Plan Commission Meeting/Public Hearing
Tuesday, September 17th, 2024
5:00pm
In Person, Online or Via Phone

To: Village Plan Commission
From: Mark Roffers, AICP, Village Planner
Date: September 12, 2024
Re: Fisk Place Certified Survey Map (CSM)

CERTIFIED SURVEY MAP

Analysis of Average Lot Size within Two Tiers of 102 Fisk Place

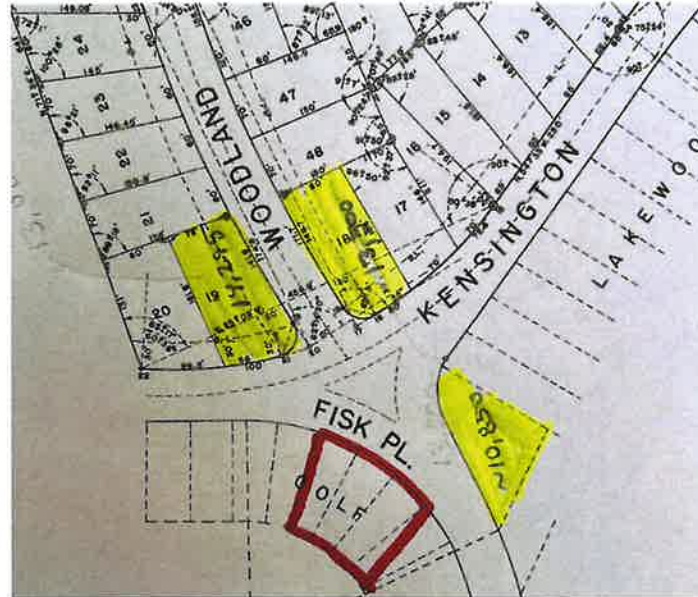
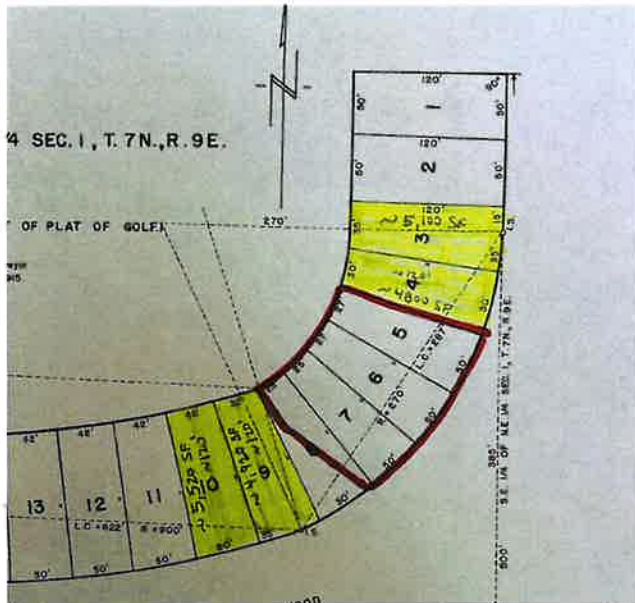
Recommendation: I first recommend that the Plan Commission rescind its April 30, 2024 determination of the exact lots to be utilized to determine an average lot size under Section 225-84 B of the zoning ordinance, and instead determine that those lots highlighted on the 9/11/24 “Analysis of Average Lot Size within Two Tiers of 102 Fisk Place” analysis be utilized.

The areas in square feet of each of the highlighted lots (and the plat they are in) are as follows:

- 5,520 (Golf)
- 4,920 (Golf)
- 4,800 (Golf)
- 5,100 (Golf)
- 10,850 (Lakewood)
- 13,500 (2nd Addn. Lakewood)
- 14,296 (2nd Addn. Lakewood)

The mean average size of the above lots is 8,427 square feet.

The panel on the left is a section of the Golf plat and the panel to the right is a section of the Second Addition to Lakewood Plat, which redivided a part of the Lakewood plat recorded before it. The red outlined area is a reasonable approximation of the proposed CSM area. The yellow highlighted areas are intended to represent "two tiers" of lots from the proposed CSM area, with the Fisk/Kensington road right-of-way representing one tier as it relates to across-the-street lots. The numbers within the highlighted lots are estimates of the area of each of these platted lots in square feet, also as represented in the box to the upper right.

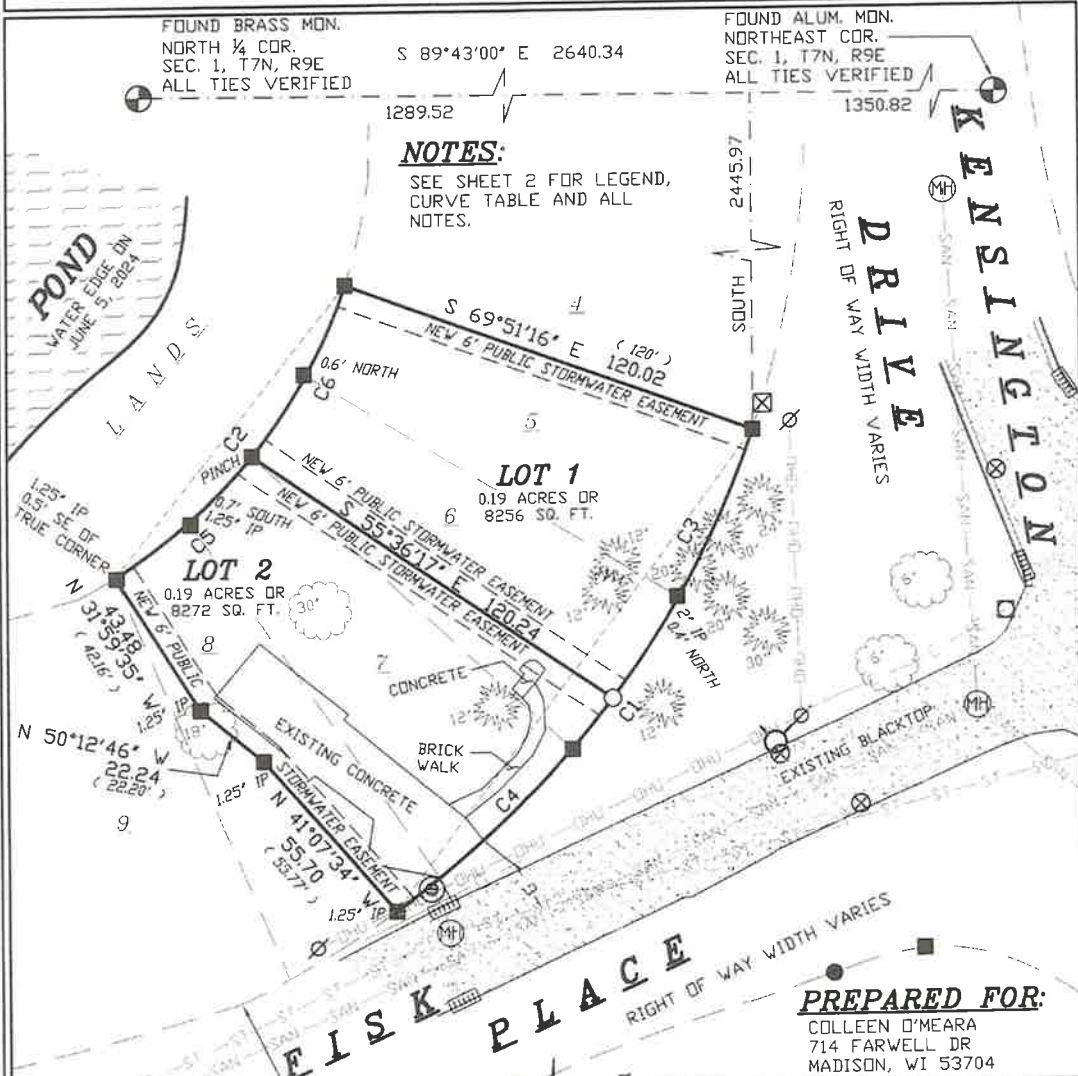
CSM Submittal Requirements (§ 225-81 B)	Comments
1. A certified survey map meeting all the requirements of § 236.34, Wis. Stats.	<ul style="list-style-type: none"> • It is my opinion that the requirements of this statutory section has been met, now that the professional surveyor’s seal has been added. • The applicants have included more items on the CSM than required by statute, like on- and off-site mature trees and utilities and more recently a “6’ public stormwater easement” along each proposed lot line.

<p>from the aesthetic desirability of the neighborhood involved.</p>	<ul style="list-style-type: none"> • The large arc of undeveloped public right-of-way in front of the CSM area does and will create the impression of larger lot areas, even though this space is publicly owned.
<p>6. The resulting lots of a parcel being proposed to be subdivided must be no smaller in square footage than required by the applicable zoning and must be within 10% of the average size of existing nearby lots. Lots to be measured for average are those within two tiers of lots in all directions of the proposed subdivision. The Plan Commission shall determine the exact lots to be utilized to determine an average lot size.</p>	<ul style="list-style-type: none"> • In April, the applicants submitted to the Plan Commission an analysis that relied the following nearby parcels as a calculation base: 409, 413, 417 Kensington; 101, 105, 114 Fisk. The average size of these lots is 9,067 square feet, and 10% less is 8,160 square feet. At its April 30th meeting, the Plan Commission approved these comparison lots for determining average lot sizes for the calculation listed to the left. • More recent evidence and interpretations suggest that the Commission may wish to rescind its April 30th action and take new action to “[re]determine the exact lots to be utilized to determine an average lot size.” • The zoning ordinance defines a “lot” as “[a] parcel of land occupied or to be occupied by one main building or use with its accessories and including the open spaces accessory to it”, and a “parcel” as “contiguous lands under the control of a subdivider not separated by streets, highways or rights-of-way.” Based on these definitions, and the Village Attorney’s opinion, it is historic platted lots and not current tax parcels that we believe should be used for this Commission determination. • The attached analysis, we believe, represents a reasonable interpretation of “two tiers of lots in all directions”. The mean average size of these seven lots is 8,427 square feet. The range within 10% this average is 7,584 to 9,269 square feet. • The proposed CSM lots are 8,256 and 8,272 square feet respectively, which fall within this range.

O'MEARA RESIDENCE
Architectural Site Plan

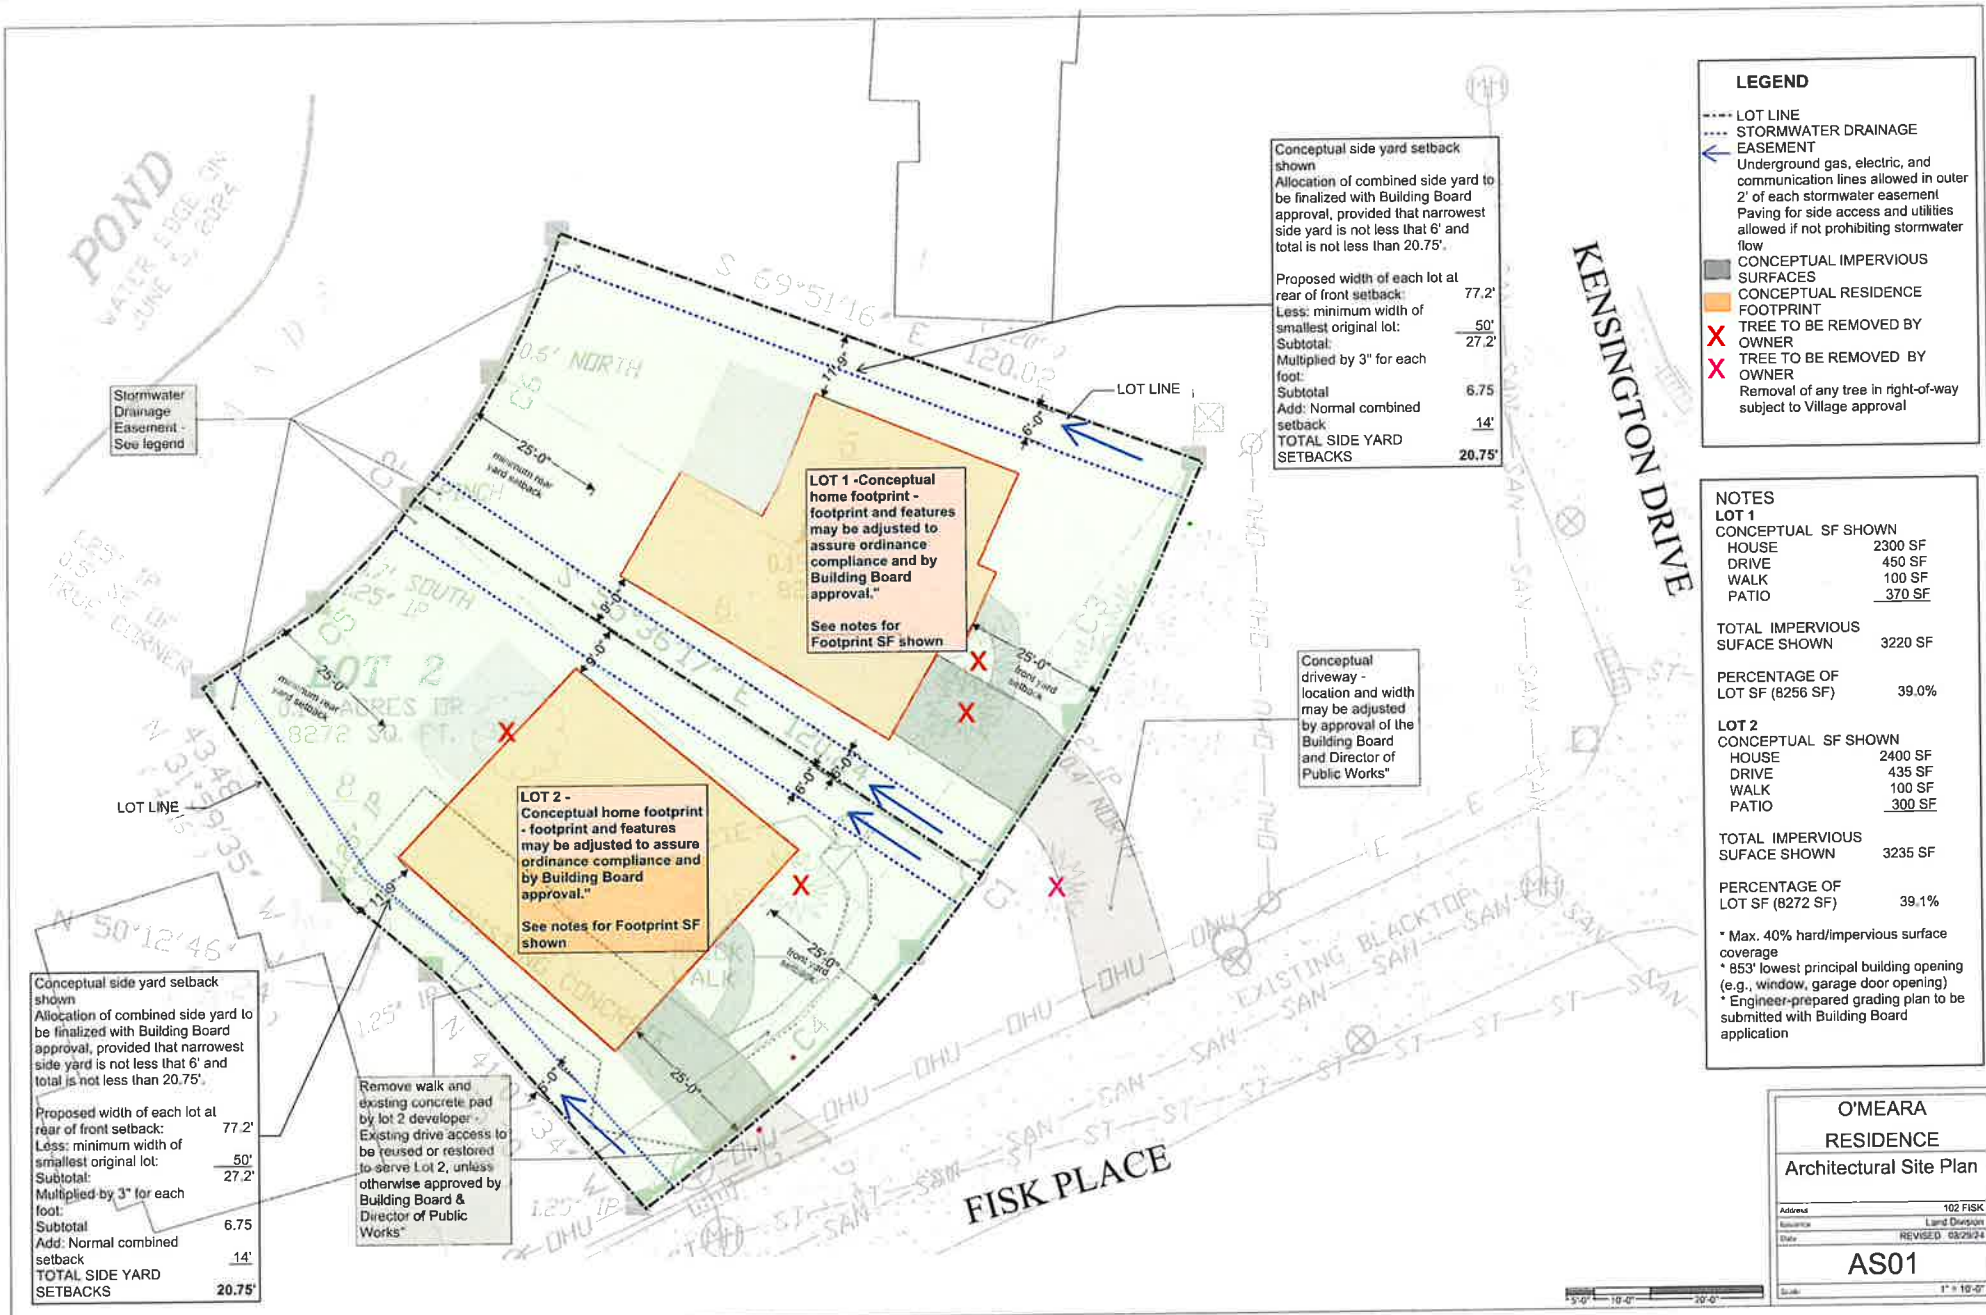
<p>grading plans that will be required before either lot may be built upon.</p> <ul style="list-style-type: none"> • See below comments on the side yard setbacks, building area, and other matters represented on the submitted preliminary plans.
CSM Review Criteria (§ 225-84)	Comments
<p>1. The proposed parcels comply with all the requirements of the zoning ordinance.</p>	<ul style="list-style-type: none"> • The proposed lots would allow for home construction in a manner that can comply with current Village requirements. • Were this CSM not to proceed, current Village zoning requirements would allow each of the three full existing “Golf” plat lots that make up this tax parcel could be developed with a single-family residence, provided setbacks were met. Alternatively, the combined tax parcel could be developed with one residence to a maximum floor area of 4,132 absent any special exception from the Building Board, and to a maximum building footprint of 4,958 square feet regardless. • I did not review this CSM against any pending requirements in the Village’s proposed zoning ordinance update. The current draft has yet to even be reviewed by the Plan Commission or Village Board, and is not likely to be ready for approval until 2025. Any provision in the current draft is speculative. The CSM must be reviewed against the ordinance in place at time of application. • Village requirements specify that a grading plan be submitted to the Building Board when each lot is proposed for building construction, meeting ordinance requirements listed earlier in this memo and now the provisions of the submitted CSM (stormwater easement) and preliminary site development plan (e.g., lowest building opening). I advise that such plan be prepared by a civil or stormwater engineer and consider stormwater conveyance both from and through each lot. • The information on the revised architectural site plan meets the limits of the maximum building area and impervious surface percentages in the zoning ordinance.

<p>2. Proposed division and development will not result in unreasonable traffic problems or safety hazards.</p>	<ul style="list-style-type: none"> • Village staff anticipate negligible traffic or safety hazards. The conceptual driveway to CSM Lot 1 has been adjusted to avoid an existing utility pole and fire hydrant. • Future efforts to bury utilities will need to be completed with care given proximity of existing overhead lines to mature trees. • The proposal would result in additional traffic associated with two-single family homes—one more than existed here historically. Traffic increases should be minimal. • Two driveways are proposed on Fisk Place. The nearest driveway is proposed to be 50+ feet from the Kensington/Fisk intersection, allowing for 3-4 car lengths of vehicle stacking along Fisk Place.

<p>3. Proposed division and development will impose no unreasonable impediments to the provision of municipal services.</p>	<ul style="list-style-type: none"> • Village staff anticipate no impediments to the provision of Village services to the proposed lots. • The applicants' revised plans and a recommended approval condition make clear that the owners (not the Village) would be responsible for all costs associated with public infrastructure or tree adjustments in the public right-of-way, and that all such adjustments would be subject to prior Village approval.
<p>4. Proposed division and development will provide adequate access to public streets.</p>	<ul style="list-style-type: none"> • Each proposed lot would have ~84' of frontage on a public street right-of-way. While the undeveloped portion of the right-of-way is certainly wider than typical, the Village commonly allows private driveways to cross undeveloped right-of-way to reach street pavement edges. • The proposed Lot 1 driveway appears to extend southwest of all but one of the mature evergreen trees within the public right-of-way. As represented, the conceptual driveway extends a bit in front of CSM Lot 2, which is allowed. • The driveway for Lot 2 is currently expected to remain in a similar location as it is today, though it may need to be replaced and the plans are drawn so that the Building Board could approve an alternate location. • The Village may have little means to compel a shared driveway.

<p>7. In the "B" Residence District, if two or more existing lots or parcels are proposed to be consolidated, any new lot(s) shall be no greater in width than 100 feet as measured at the street right-of-way. Also, applicable side yard setback requirements shall increase three inches for each foot such proposed lot is wider than the smaller of the initial lots proposed to be consolidated.</p>	<ul style="list-style-type: none"> • This CSM would consolidate 3+ existing platted “B” Residence lots into 2 lots, so this provision applies to this proposal. • Neither new lot would be over 100 feet in width at the right-of-way • The applicants have adjusted their architectural site plan to accommodate the setback adjustment requirement to the left. Each of the platted Lots 5-7 has 50 feet in width at the street line. This adjustment would add nearly 6.75 feet to the normal minimum 14 foot combined side yard setback for each proposed CSM lot (20.75 feet total). This is represented on the applicants’ preliminary architectural site plan. This is a slightly different result than I shared in my earlier memo. The Village Attorney, Zoning Administrator, and I now agree that the lot width in the second sentence to the left ought to be measured from the minimum front building setback line, which is the normal way of measuring lot width per the zoning ordinance.

1. The CSM shall be recorded within one year of its approval or such approval shall be null and void.
2. The CSM lots shall be developed in accordance with the “102 Fisk Place – Preliminary Architectural Design” and “O’Meara Residence Architectural Site Plan” (both dated 8/29/24), subject to the flexibility provided therein or as otherwise may be approved by the Village Board after Plan Commission recommendation.
3. The owner shall pay for any changes in public improvements and utilities, and for tree trimming or removal, which may be required in development of the CSM lots. No changes may be made within the public right-of-way without prior approval of the Public Works Director.
